# OFF LEASE ONLY PD & MASTER PLAN

## SUMMARY

Staff recommends approval of ZON2015-00022 and MPL2015-00022, subject to the following conditions:

# PHASE 1— DEVELOPMENT PLAN

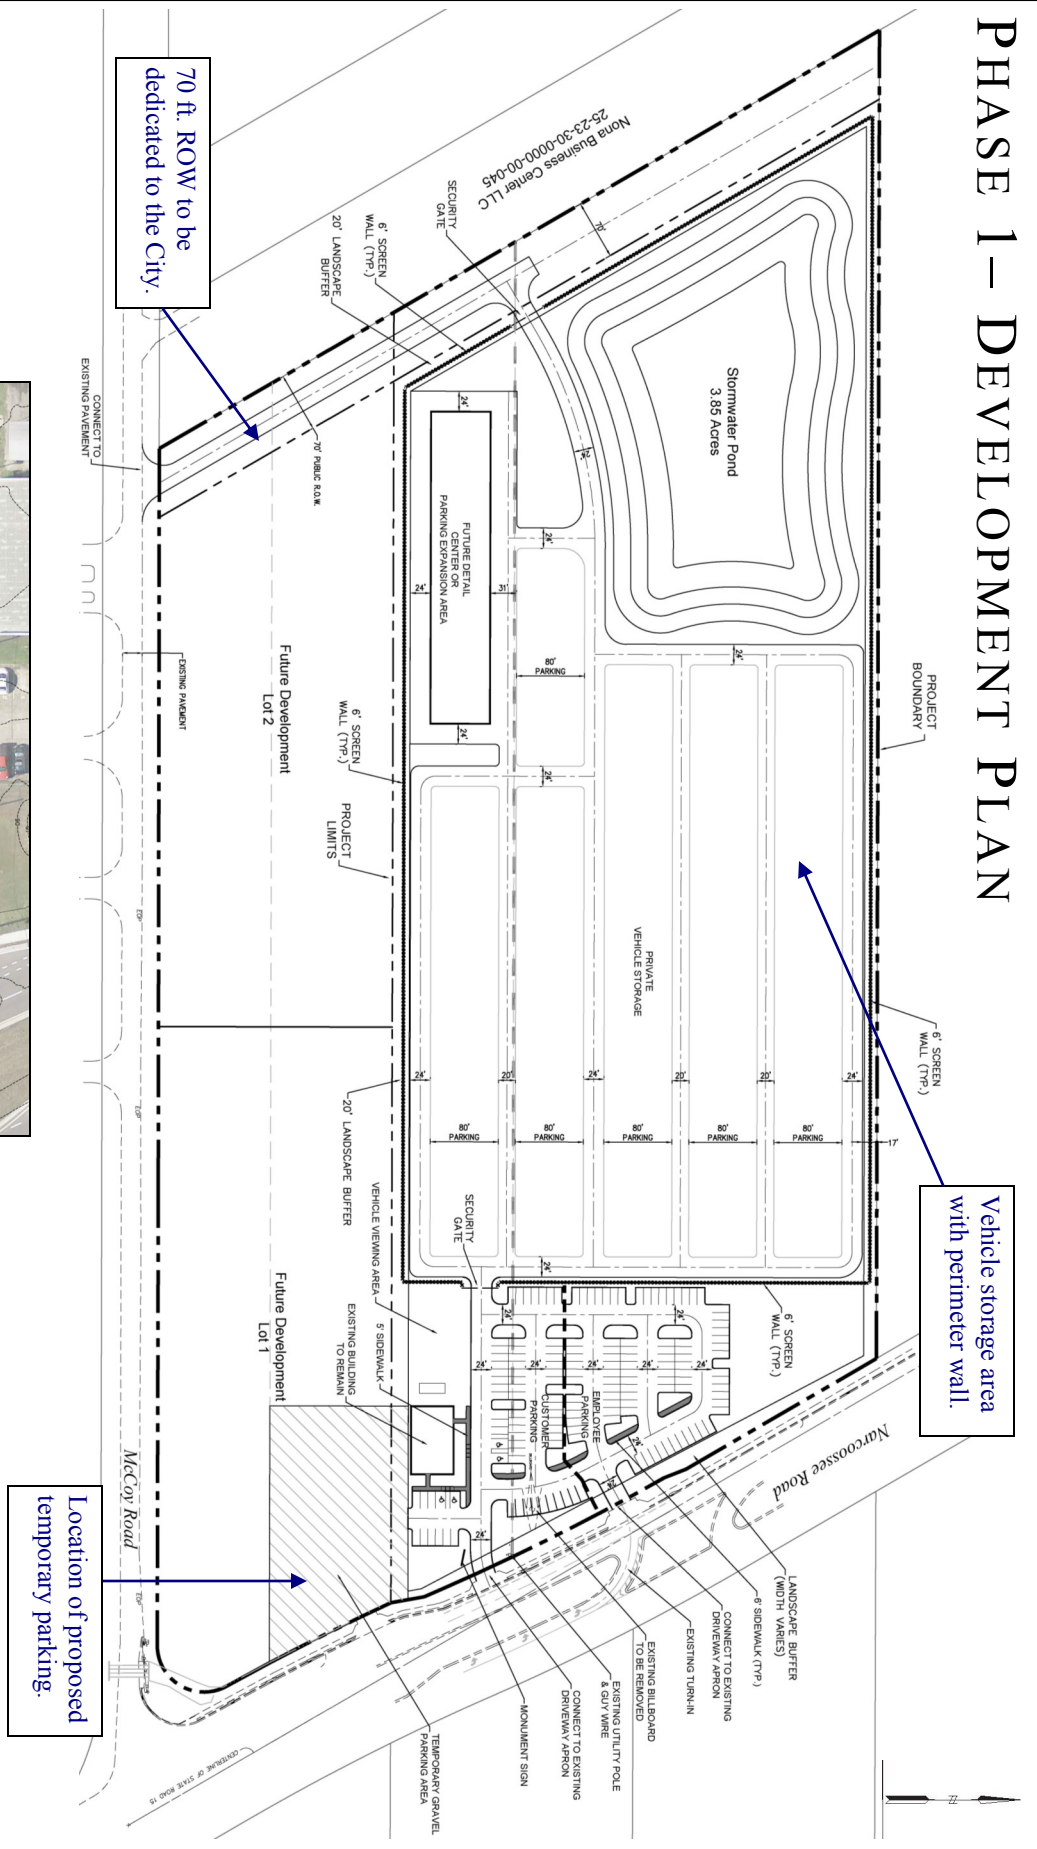
The applicant proposes the use of a temporary gravel parking area on Phase 3, adjacent to the southeast corner of Phase 1. This temporary area will be to allow the continued operation of the business during construction. The use of gravel shall not be permitted but a coarse aggregate, no smaller than standard size #4 may be used. To ensure the addition of temporary parking is not provided without the prescribed expansion, or that the temporary use is not continued upon completion of the expansion, several conditions relating to timing have been provided by staff.

## TEMPORARY PARKING

Area to remain landscaped with hedge to be provided for screening from ROW.

A. Use of stone shall be prohibited within 15 ft. of the ROW.

B. A landscape hedge, minimum 24 inches at planting, shall be provided for screening along Narcoossee Rd.

C. Permits for this temporary lot shall not be issued until permit application has been made for Phase 1 construction.

D. The temporary parking area shall be restored to its original or an improved state by January 2017 or issuance of a certificate of occupancy or completion for Phase 1, whichever occurs first.

TYPICAL SIGN DETAIL  
MAX. COPY AREA 25.5\"/>

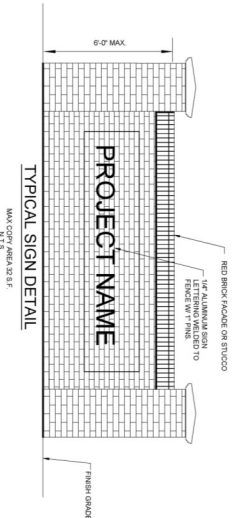
The Phase 1 development includes a 6 ft. tall wall around the perimeter of the vehicle storage area. The wall shall incorporate rod-iron or a similar CPTED type fencing to allow crime prevention while maintaining the security of the vehicle inventory. The final wall design shall require Appearance Review. A total sign copy area of 100 sq. ft. is permitted for Phase 1 based on the existing building proposed to remain onsite. A 6 ft. tall monument sign is proposed along Narcoossee Rd.

15. Pole Signs. Pole signs are prohibited and monument signs shall not exceed 10 ft. in height.
